Agency Advice on Environmental Assessment Report

RE: NRE No1 Colliery Underground Expansion Project

**NRE No.1 Colliery Underground Expansion Project (MP 09_0013)
Response to exhibition of Environmental Assessment**

Figure 1. Subsidence “visualisations” for the Wonga West domain from Seedsman Geotechnics (2010) left and Seedsman Geotechnics (2012) right.

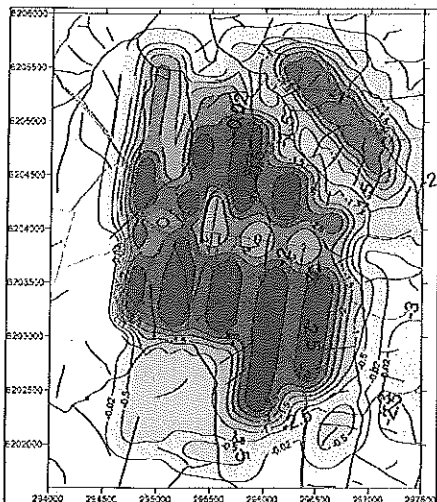
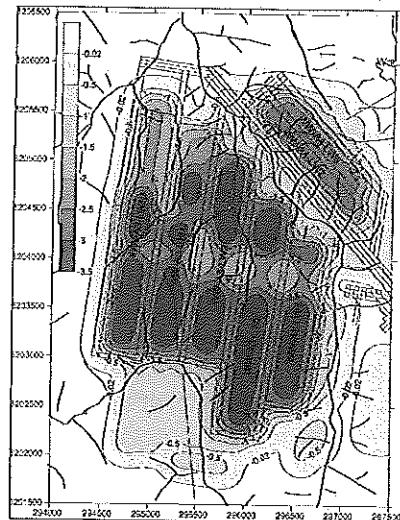
- *"A large degree of judgement has been used to decide on maximum vertical subsidence outcomes for the various layouts that are proposed".*
- *"Base Case Wongawilli West subsidence prediction and visualisation is based on a very large degree of judgement in the absence of calibration/validation data"*
- *"The available subsidence data has been manipulated to give an indicative contour plan of the vertical subsidence across the first 4 panels" (no details on the 'manipulation' applied)*
- *"Based on a large degree of judgement there may be some valley closure and upsidence in these creeks, possibly in the order of 100mm" and*
- *"It is acknowledged that there is a need for calibration and verification before these can be used as predictions".*

While the above phrases now no longer appear in the Seedsman Geotechnics (2012) report, the subsidence methodology and predictions used in the current EA are still essentially the same – i.e. based on exactly the same methodology as described in Seedsman Geotechnic (2010). In addition, despite detailed discussions about the potential impacts of the proposed mine and adequacy of subsidence assessment (alluded to in Seedsman Geotechnic 2012 p.6), little to no change occurs to the subsidence "visualisations", particularly in the Wonga West domain (see Figure 1). It is these "visualisations" which form the underlying predictive base for subsidence assessment and risk assessment in the current proposal.

While OEH appreciates the technical difficulties and uncertainty inherent in any subsidence prediction methodology under such difficult conditions (and lack of knowledge), OEH does not support a trial and error approach to mining utilizing such wide, untested and potentially damaging panels in what is a very sensitive and important area. **OEH suggests that the risk assessments in the EA are highly flawed (especially for streams and swamps) and have not validly considered the potential impact of valley upsidence and closure movements of the magnitude likely to occur for this proposal.**
